Re: Initial Submission Review: Prairie Point Site Plan No 5 – Site Plan and Plat and Plat

Application Number: DA-1609-29

Case Numbers: 2024-4022-00; 2024-3049-00

EXISTING LEGEND

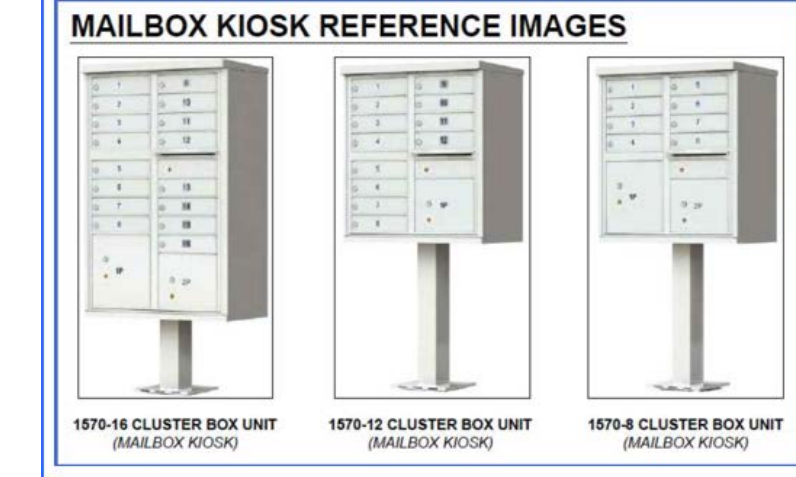
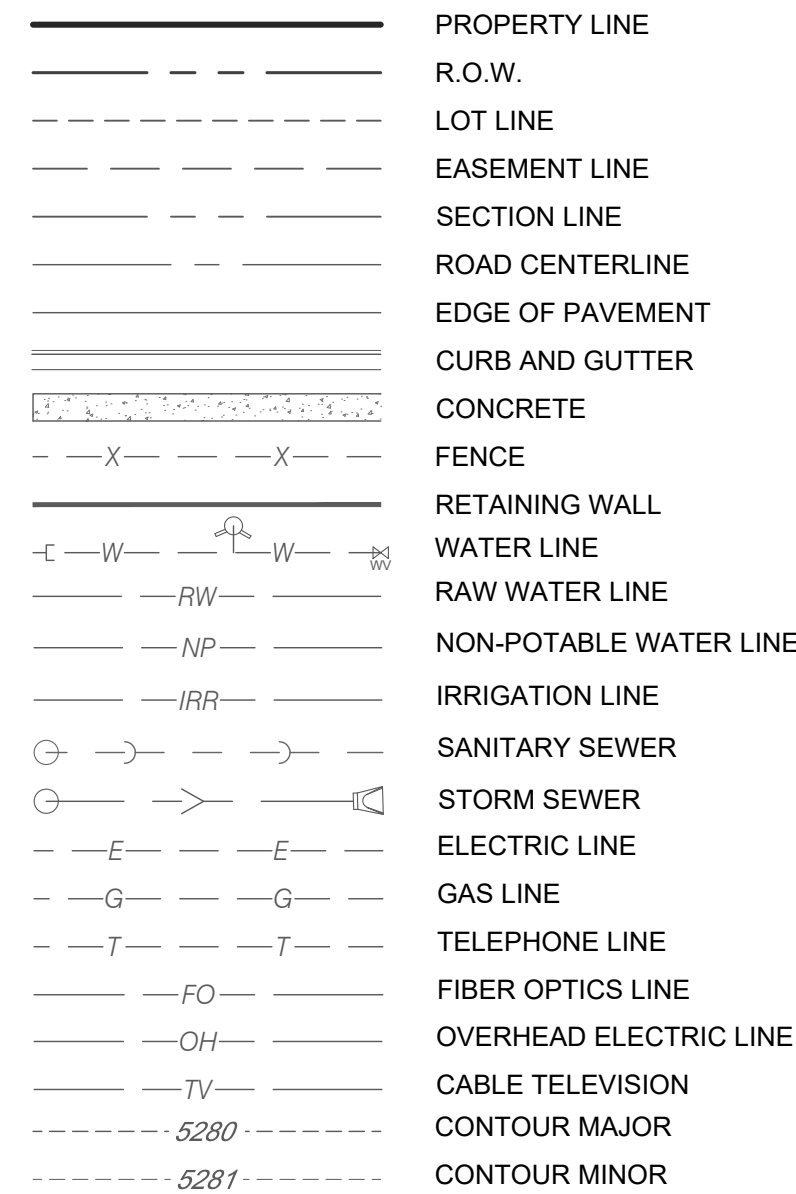
Please indicate both existing and proposed Fire Hydrant within the legend.

Please provide a Mailbox Kiosk Detail

Has The United States Postal Service been contacted regarding the Kiosk and approval of delivery method?

Legend updated.

This has been updated.

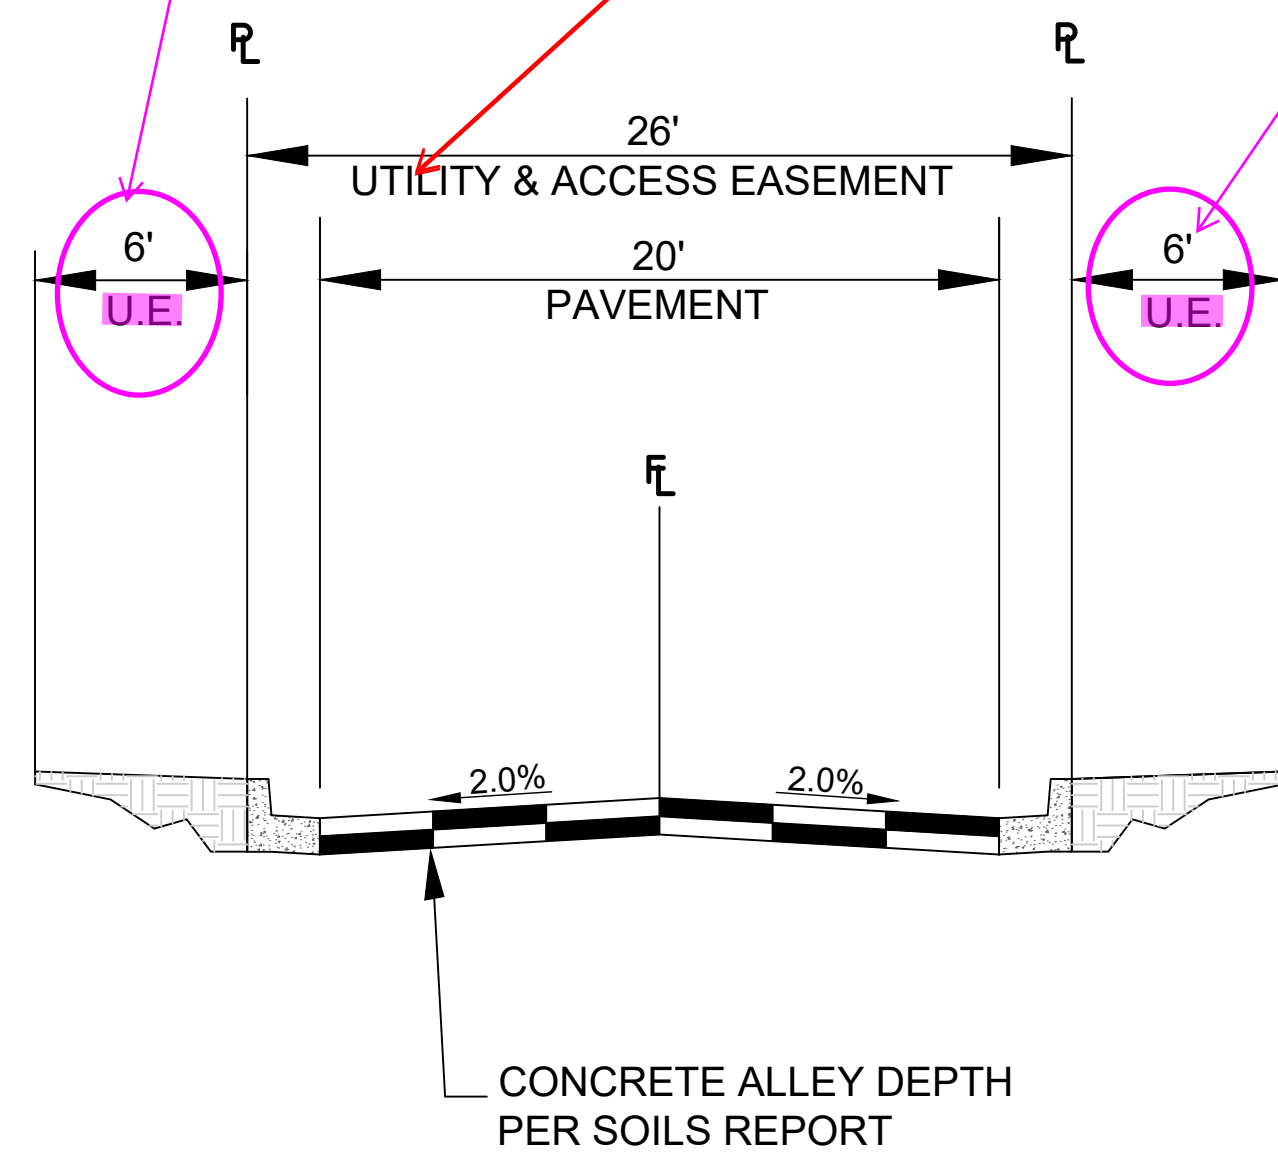
Revise to Water, Sanitary and Access Easement.

Please confirm with Aurora Water that the Proposed Water Meters need to be in a Water easement (Typ.)

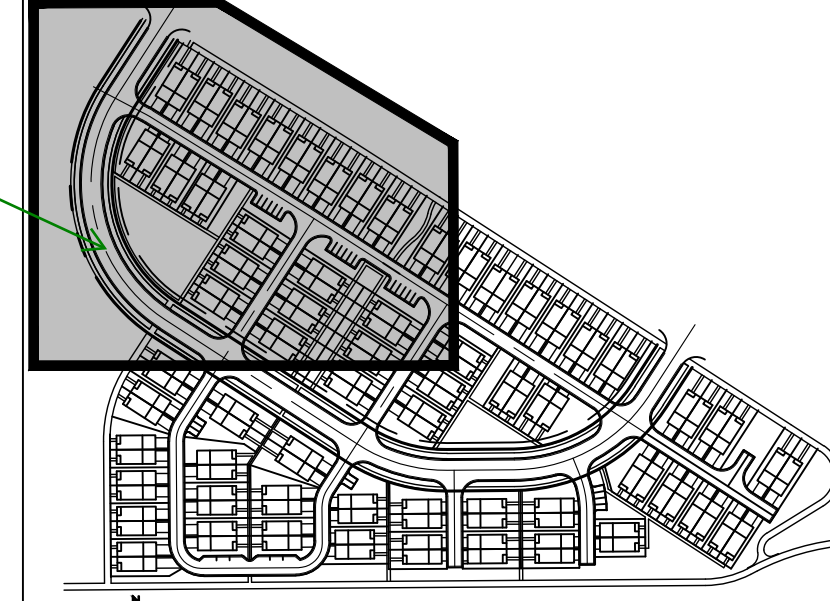
It is going to be hard to see around these parking spaces because they are all in the sight triangle.

Dimension existing sidewalk (TYP.)

Sight triangles removed.
remove sight lines

SW dimensioned.

PRAIRIE POINT SUBDIVISION FILING NO. 5
SITE PLAN
GRADING PLAN INDEX

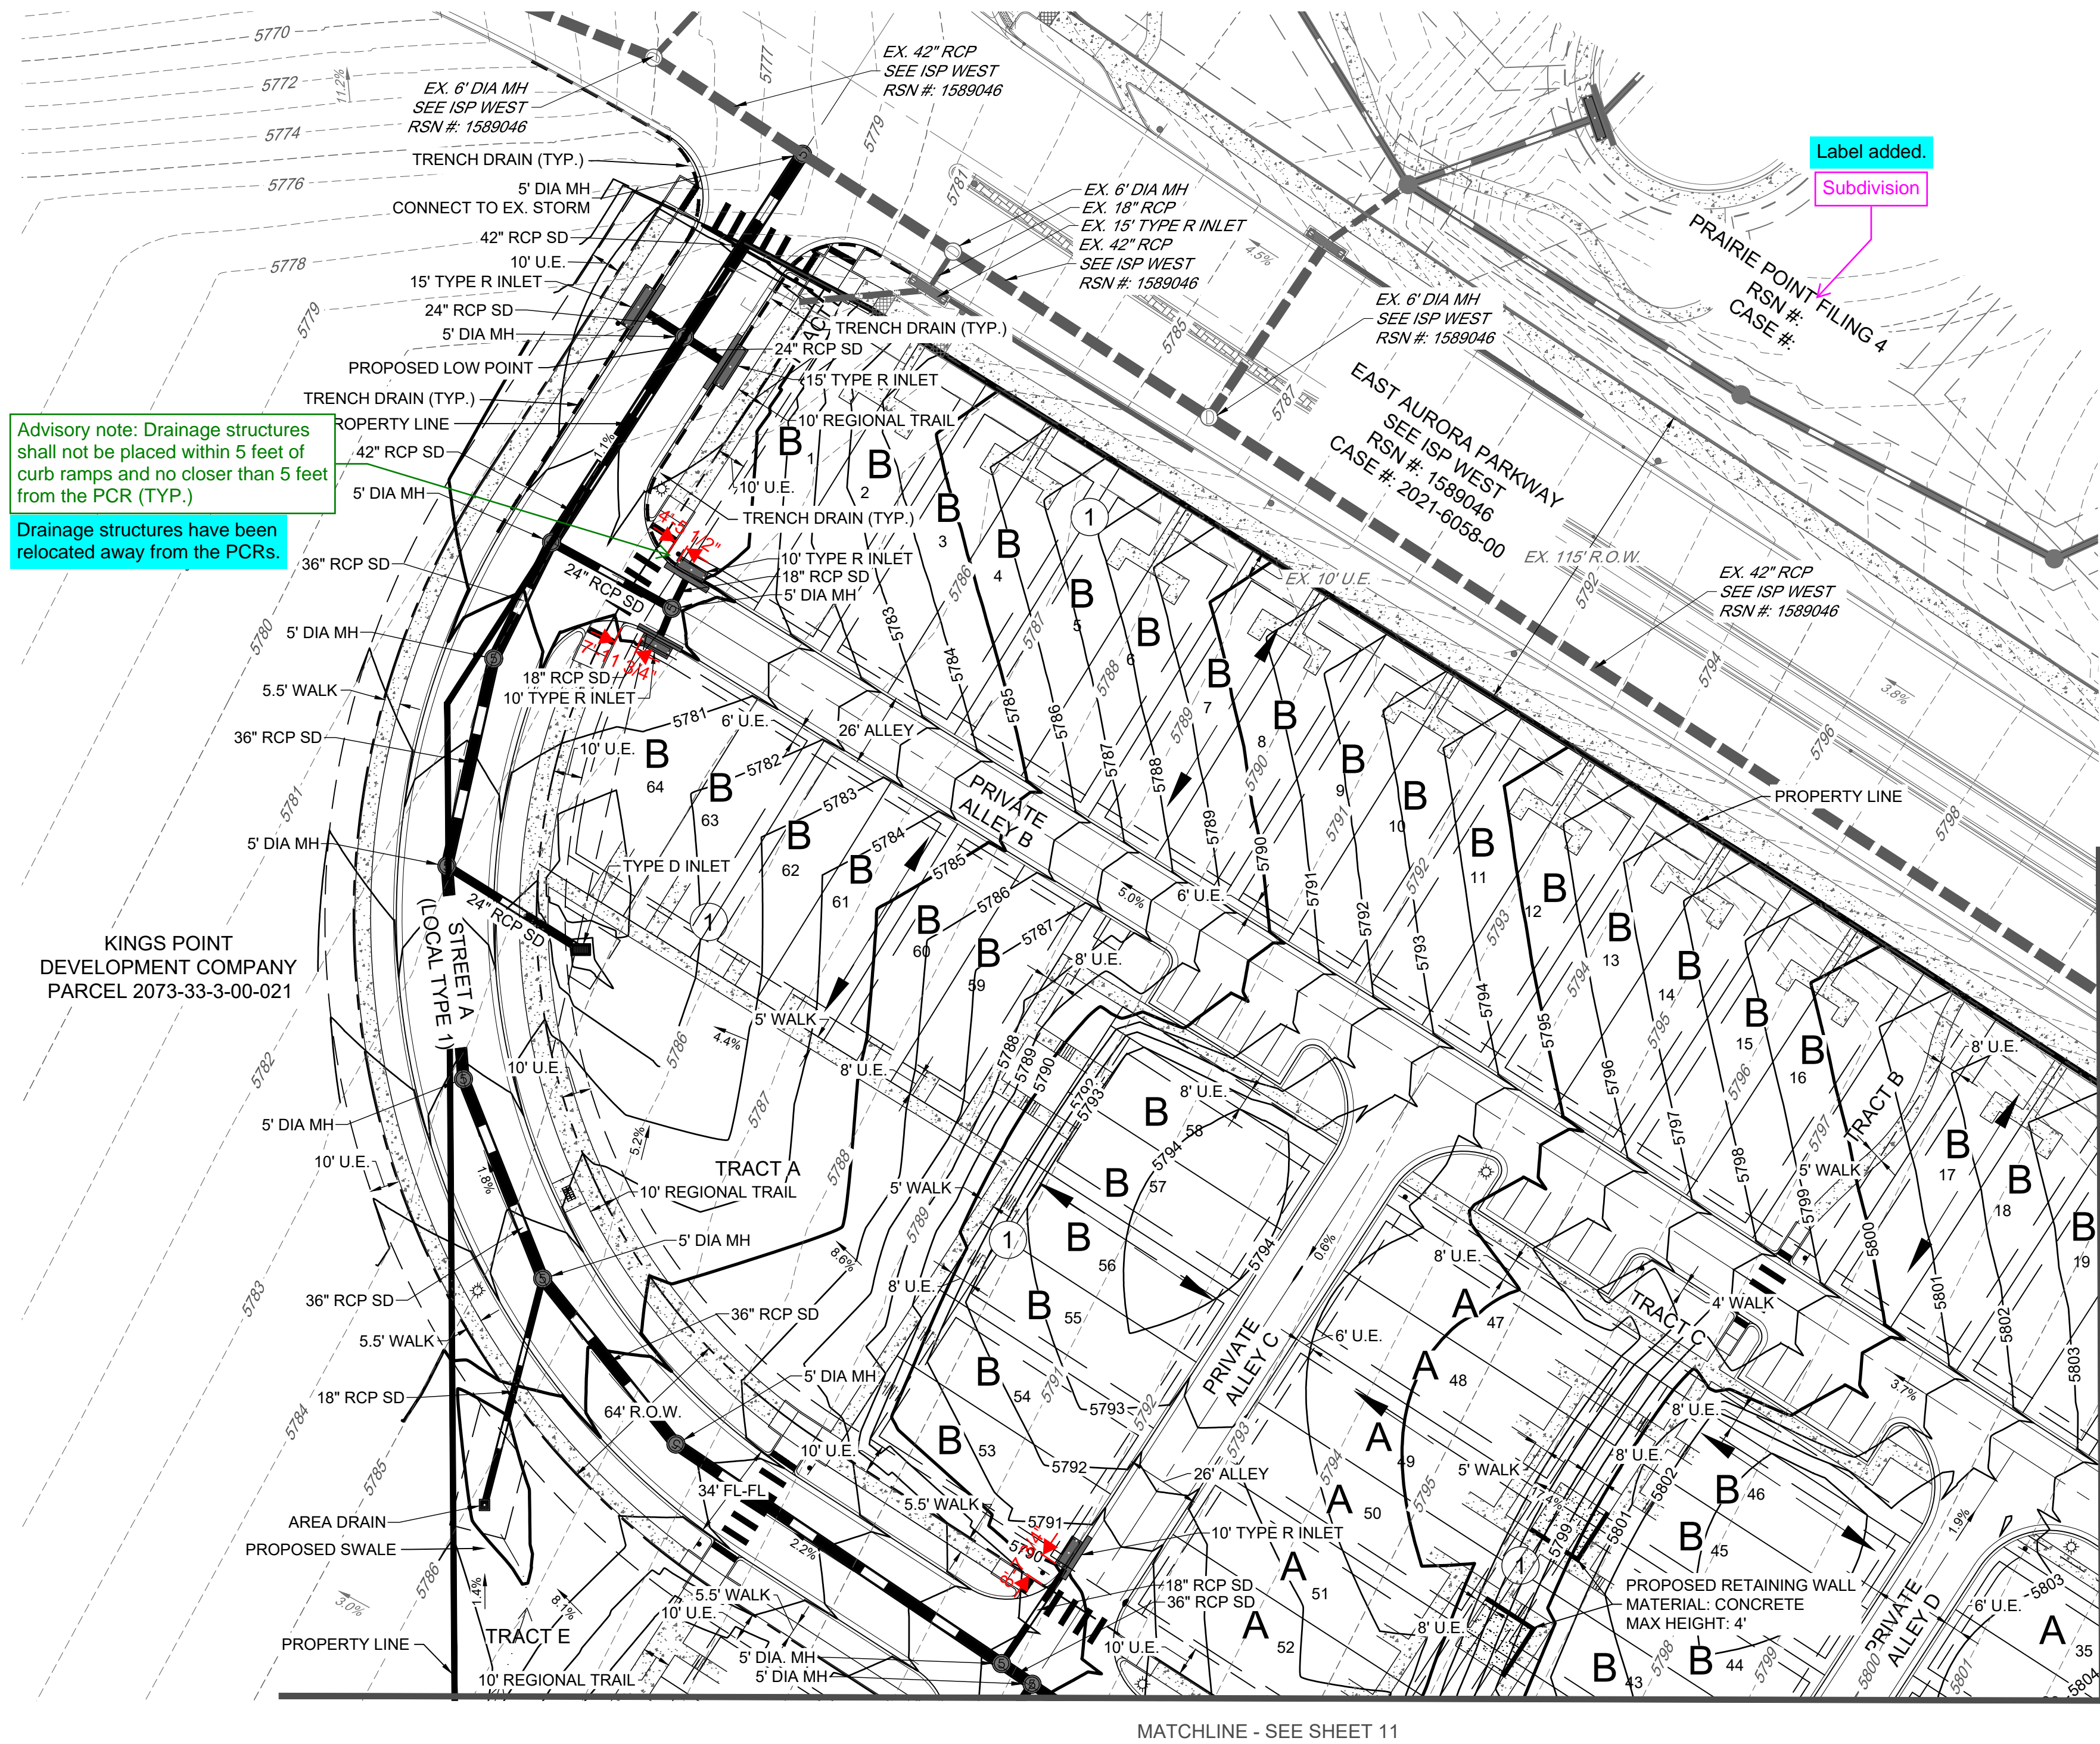
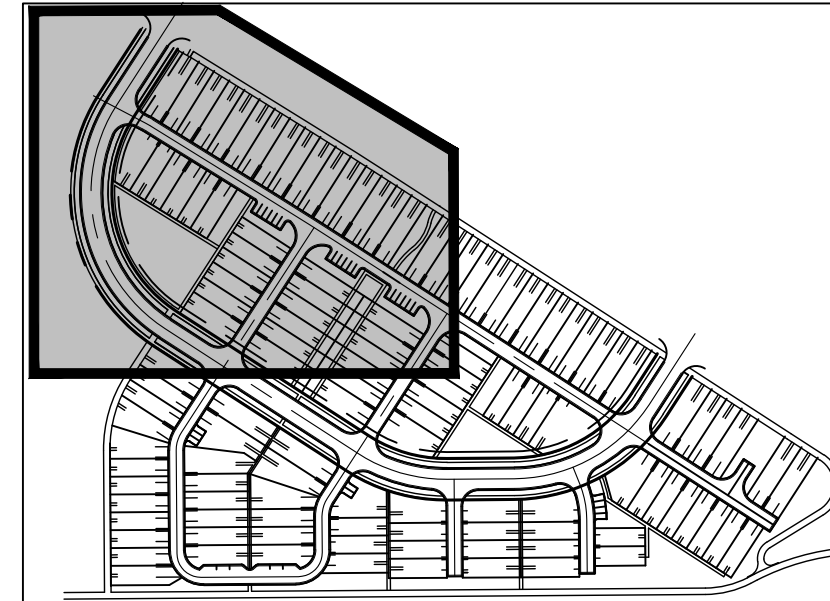
Advisory note: Drainage structures shall not be placed within 5 feet of curb ramps and no closer than 5 feet from the PCR (TYP.)

Drainage structures have been relocated away from the PCRs.
